Independent Arboricultural assessment of an outline planning  
application for 120 dwellings

Land opposite Heath Farm,  
Briary Lane,  
Royston,  
Hertfordshire

Planning application 20/00744/OP/OP

On behalf of Royston Says No To Gladman

Figure 1 – extract from Figure 4 of the Design and Access Statement

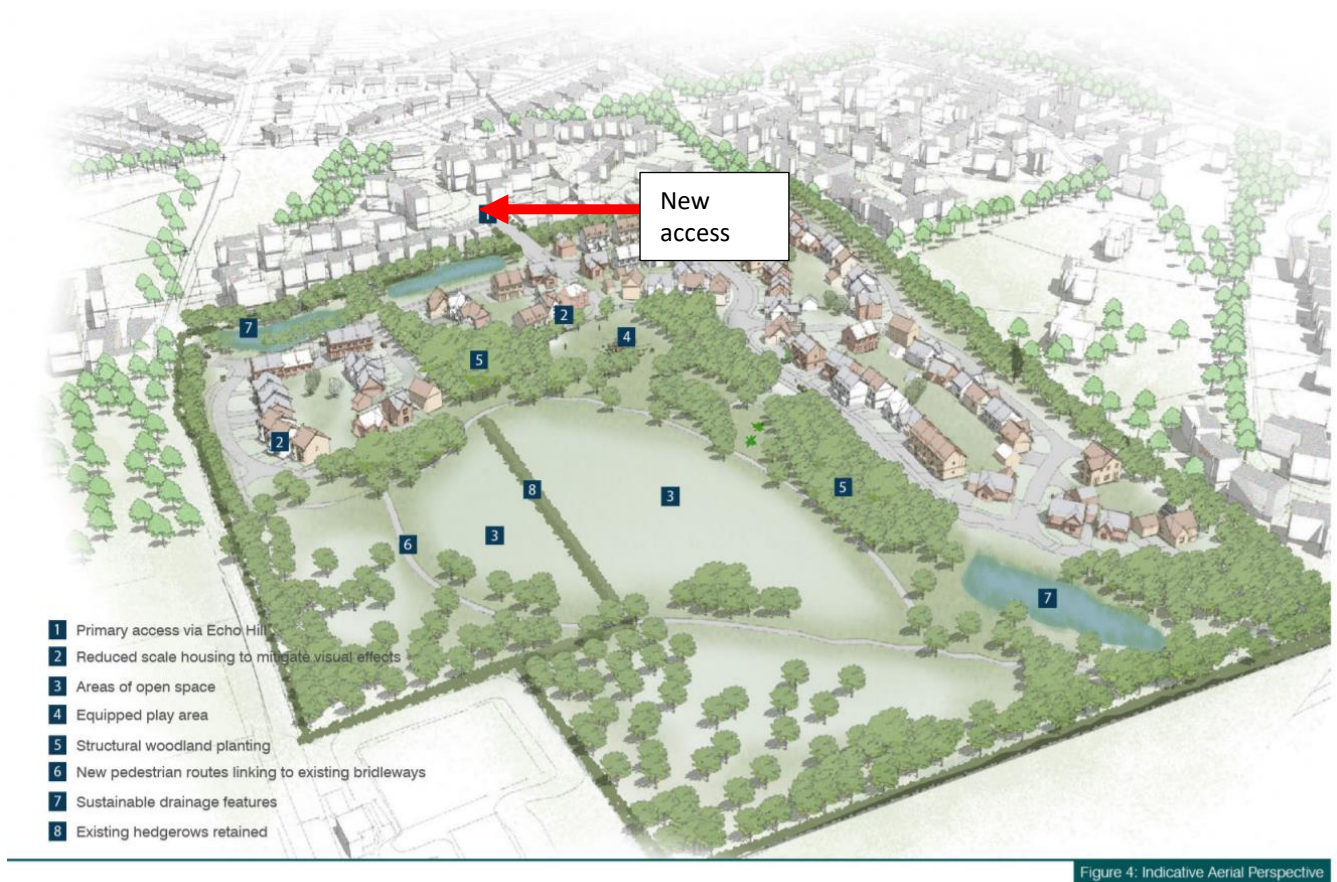
- The access is from Eco Hill (see annotation 1 on the drawing)
- There are 21 fewer dwellings
- Briary Lane will become a cycleway and Emergency Access (likely to require resurfacing to meet standards)
- Required Highway improvements to meet standards results in a widened footpath on the southern side of Sun Hill.

*Photo 1 of the trees along the bridleway looking south (notated as G8 in the Arboricultural Impact Assessment). Note how the trees inform the landscape character when viewed from the south of Royston.*

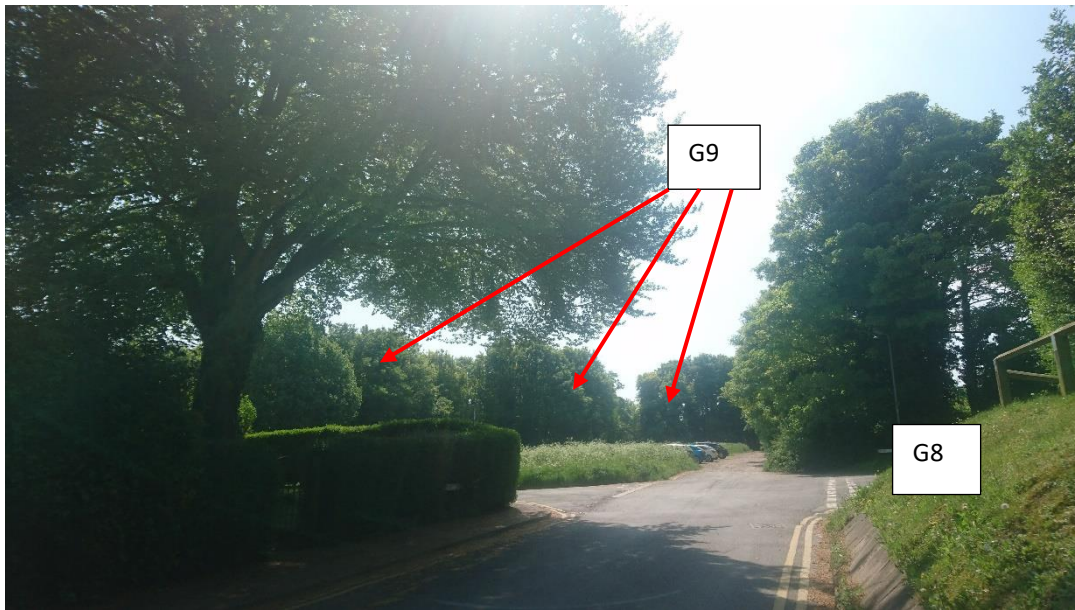
The site accessed by Public Bridleway 13 from Sun Hill in the north to open arable landscape to the south. The trees along the bridleway form continual canopy cover from the junction with Sun Hill until the farm house complex to the south. The trees (notated as G8 on the arboricultural impact assessment) form a screen separating Therfield Heath to the west from residential development to the east.

*Photo 14 of the bridleway*

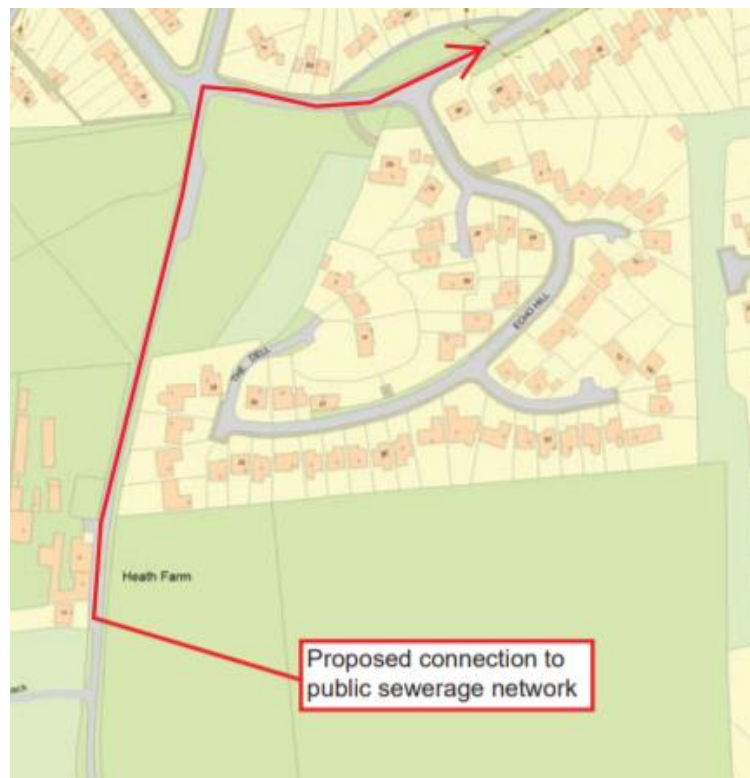
There are specialist methods to achieve minimal dig construction, but these are rarely adopted by the Highway Authority. The reality is that roots will be severed to achieve the construction which will compromise the health and structural stability of the trees, resulting in them being felled. This will create a considerable loss of amenity to Therfield Common which is a Site of Special Scientific Interest.

*Photo 15 of trees along the bridleway, looking east from Therfield Common which could potentially be removed if the bridleway was to be improved to enable emergency access and cycleway.*

Figure 3 – extract from 1517/23 A from Transport Assessment. Do not scale. North is vertical.

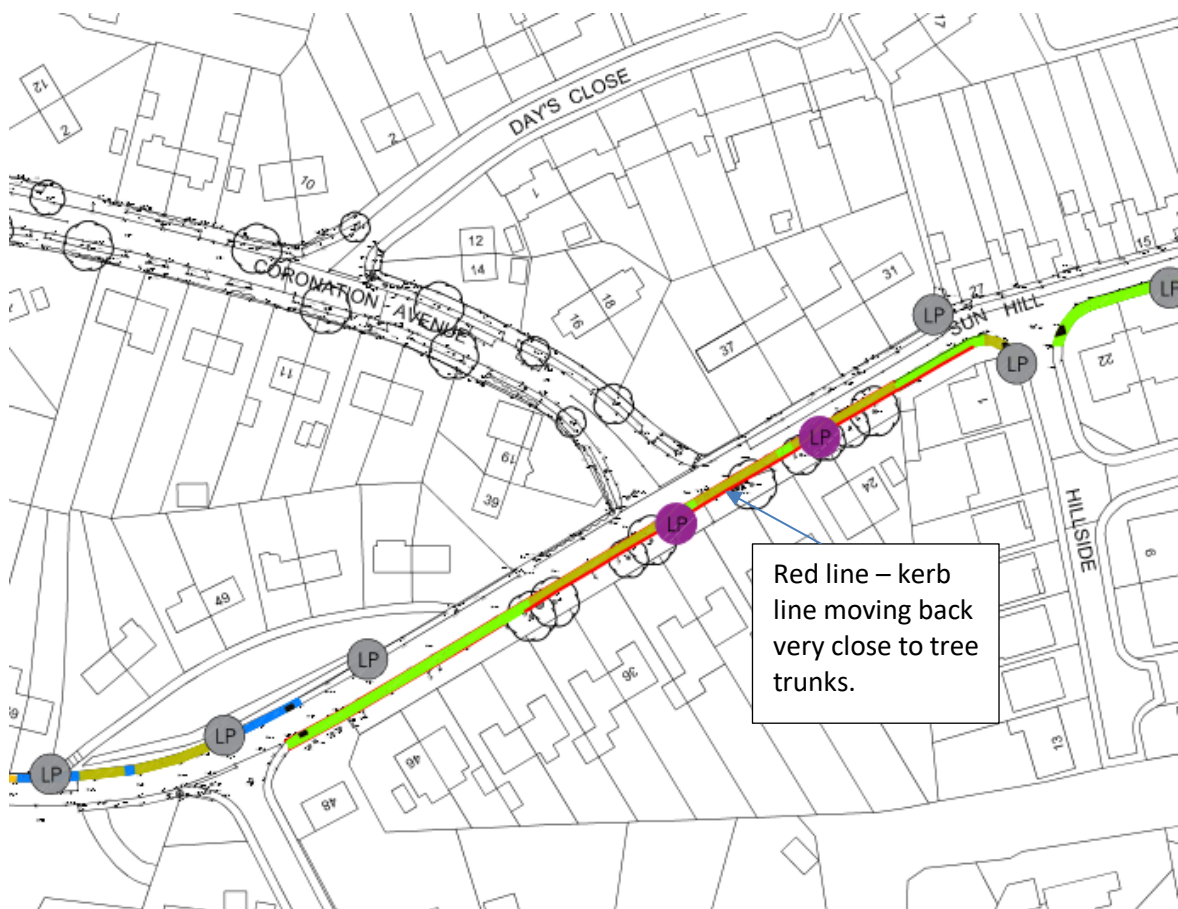
The drawing shows that the kerb line will be moved south along a line of existing trees along part of Sun Hill. The pertinent area for trees (SHA T1 – T8 see photos 6 – 13) is shown on the plan extract below:

These trees have not been surveyed as part of the Arboricultural Impact Assessment. Widening the footpath as shown on Figure 3 results in severing the main buttress roots. Not only would the ground need to be leveled with the pavement, but it would need to be dug down to enable Highway standard construction (for a footway, typically 450mm). This would lead to a total excavation of at least 800mm. This would certainly lead to major root severance on the road side, leading to loss of stability and the loss of the trees' ability to carry out normal physiological functions. They would need to be felled.
